INDESIT company

BAN12NFSUK

51520L0 Exploded views

N1030092FIG1

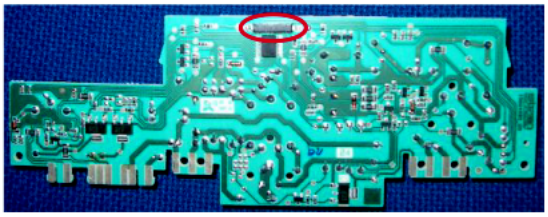
n1030092: PCB 119388 (new reed switch position) mechanical no-frost fridge-freezers(Melano

As from September-05 (serial number 50901.0001) the factory started installing a control panel PCB with the reed switch positioned on the upper side of the board on Ariston no-frost fridge-freezers (05 range) (see N1030092fig1).
This modification was needed to improve alignment between the reed switch and magnet for the door open signal (the reed switch was initially mounted on the bottom of the PCB (solder side), see photo N1025150fig2.
Moving the reed switch on the PCB also involved modification of the cabinet control panel, on which the two tabs have been eliminated to allow the PCB to be fitted correctly (see photo N1025150fig3).
On premodification models replacing PCB P/N 119388 calls for the service engineer to remove the two tabs from the control pane

The PCB and and cabinet control panels managed as replacement parts are already aligned with the modification described.

C00119618
C00140642
C00140841

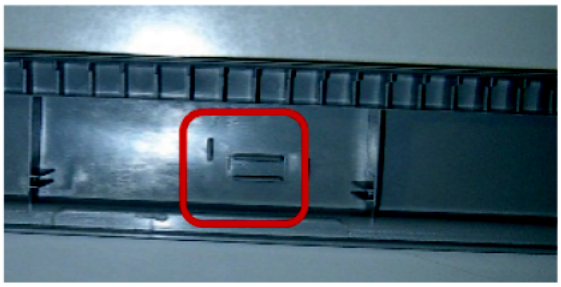
Parts affected:

C00119388(Rohs 143103) - ELECTRONIC THERMOSTAT PCB (FZ NF-MEC)

C00119618 - POLAR WHITE CONTROL PANEL (MECHANICAL-NF) 596X55
C00140642 - ALUMINIUM CONTROL PANEL (MECHANICAL-NF) 596X55
C00140841 - SILVER CONTROL PANEL (MECHANICAL-NF) 596X55

N1030102FIG1

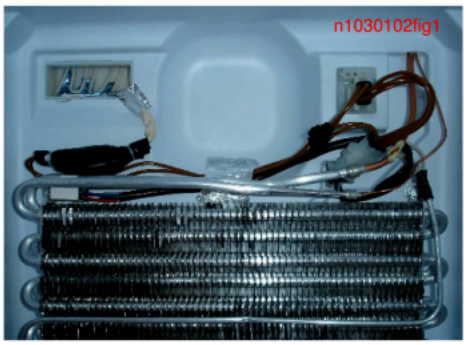
n1030102: Ice formation in the duct

There are managed two kits C00143953 and C00271924.

Check the Technical Bulletin TB001008

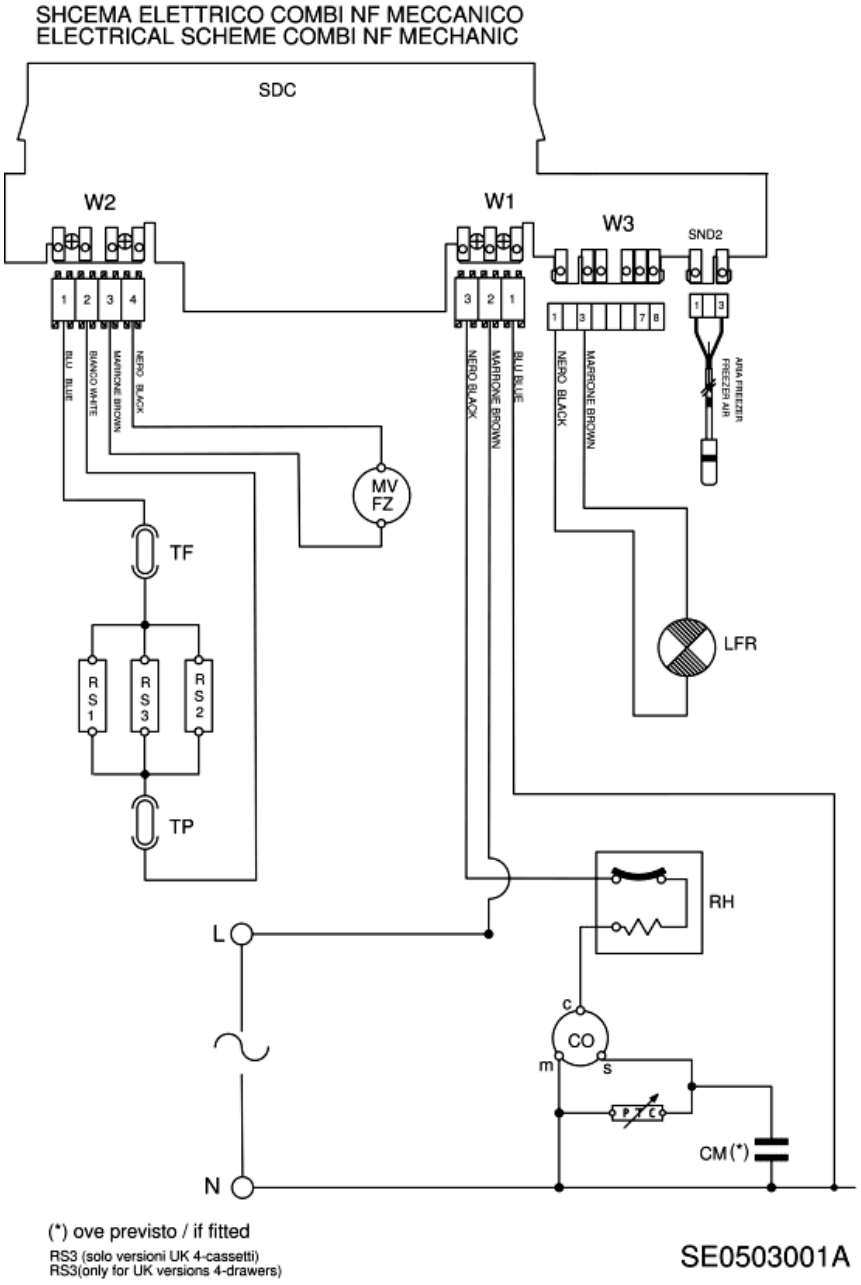
n3009i01: CHANGE DAMPER

OLD version C00118571 is not interchangeable with C00275656 (replace C00118571 with C00275656=OK; replace C00275656 with C00118571=KO).

OLD version C00275656 is not interchangeable with C00285439 (replace C00275656 with C00285439=OK; replace C00285439 with C00275656=KO).

C00118571 will be used until the end of pieces in stock, after that moment it will be manged only new version C00275656.

C00275656 will be used until the end of pieces in stock, after that moment it will be manged only new version C00285439.
